FIELD SERVICE CAMPAIGN – 17114R1

03 October 2017

Predictive Cruise Control Software Update

International® LoneStar®, ProStar® and LT™ Series

Figure 4. My Documents Folder

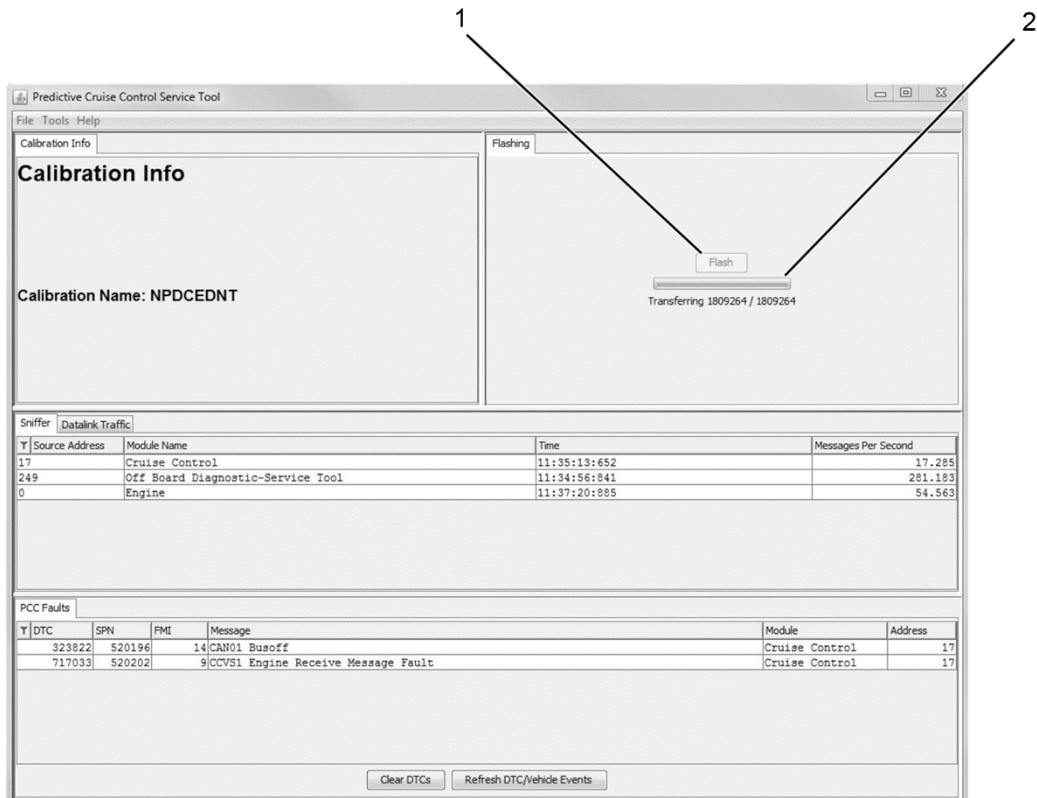
Step number 12 has been added along with Figure 4 and Figure 5.

12. When file selection box opens, navigate to My Documents and select the .SREC file. Click OPEN.
